**KERR-MCGEE CORPORATION**

Please refer to our conversation of April 3, 1973 wherein you asked us for additional information on our March 7 submittal of "Application for Amendment to License SUB-1010, Docket 40-8027, Disposal of Raffinate Liquids."

FIGURE A

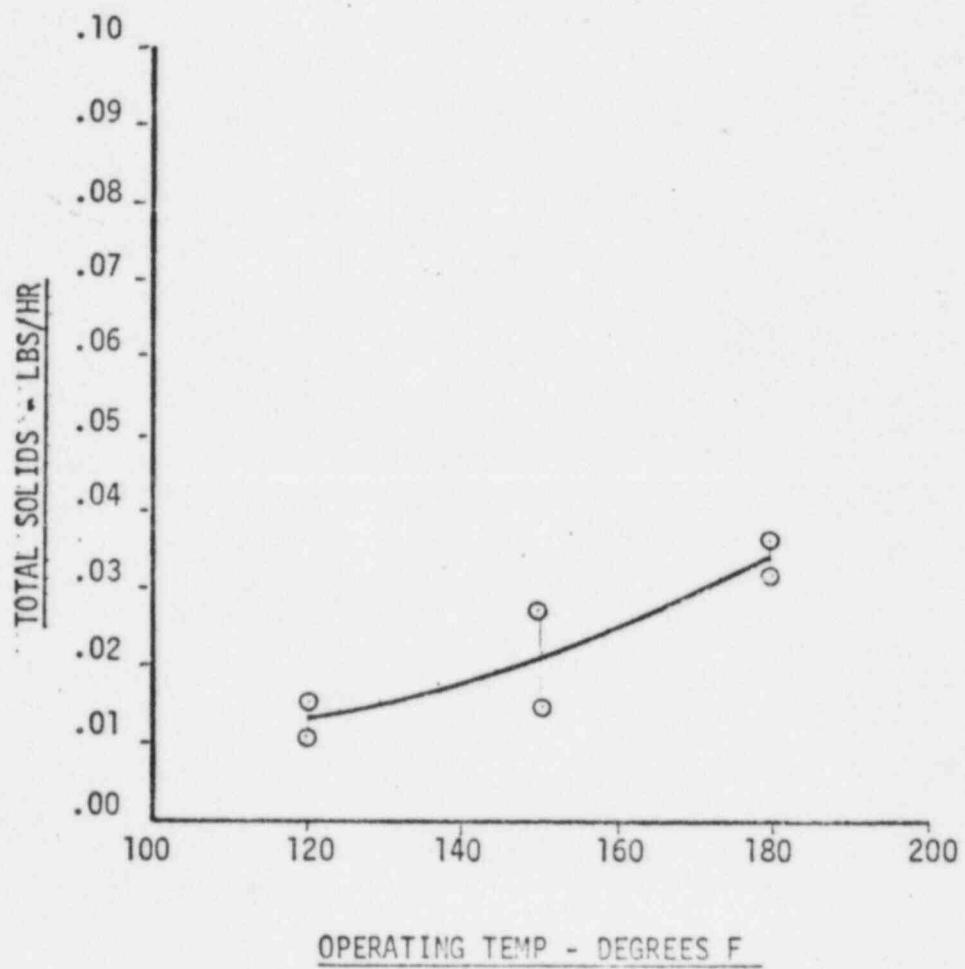
3. Calculations of stack emission were based upon Figures A, B and C attached. Data was collected as a part of similar operation or from Run No. 9 with the exception of the ammonia content which was specifically selected as 21 mg/M³ from Run No. 5 using neutralized raffinate.

FIGURE A

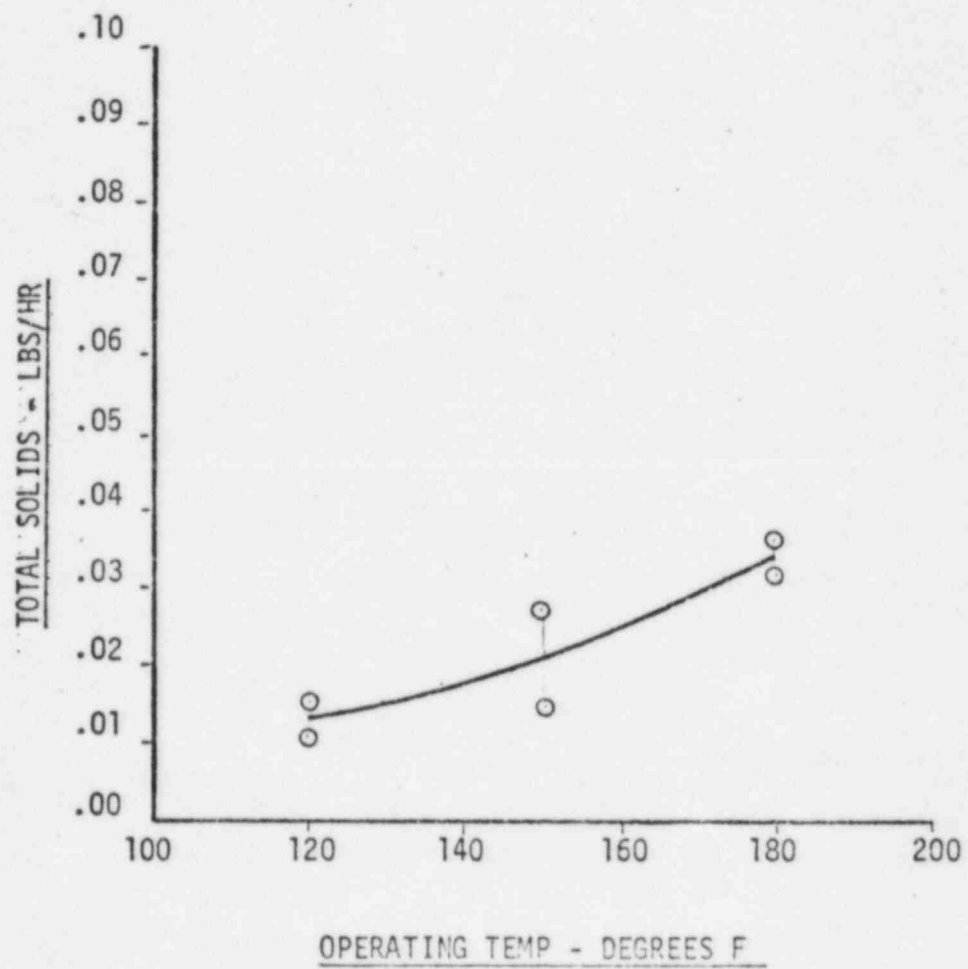
3. Calculations of stack emission were based upon Figures A, B and C attached. Data was collected as a part of similar operation or from Run No. 9 with the exception of the ammonia content which was specifically selected as 21 mg/M³ from Run No. 5 using neutralized raffinate.
